Product Change Notification (PCN)

PCN #: 8D-2023

DATE: August 3, 2023

IG60 series

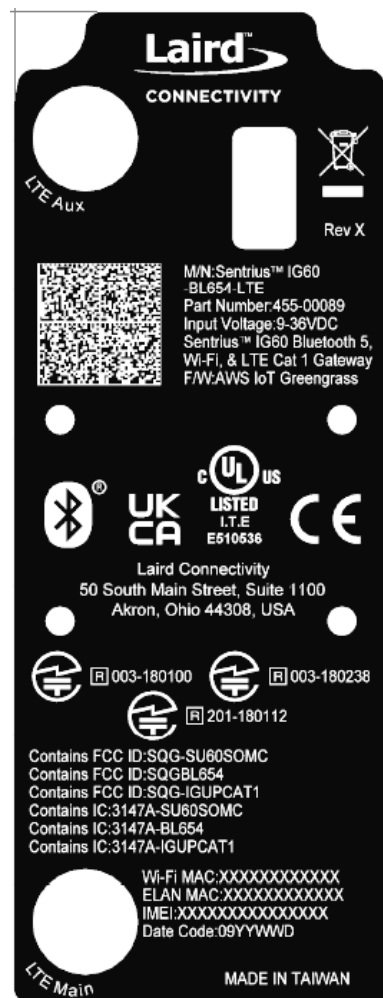
- The OUI change has no hardware or electrical impact on the devices.
- Labeling of the devices utilizing the new OUI (B0FB15) will change. The change is to replace the old OUI with the new one. Examples, by product, are shown in section 5 of the PCN.

After this PCN, the ELAN MAC printed on the product label and embedded in the 2D barcode will have B0FB15 OUI.
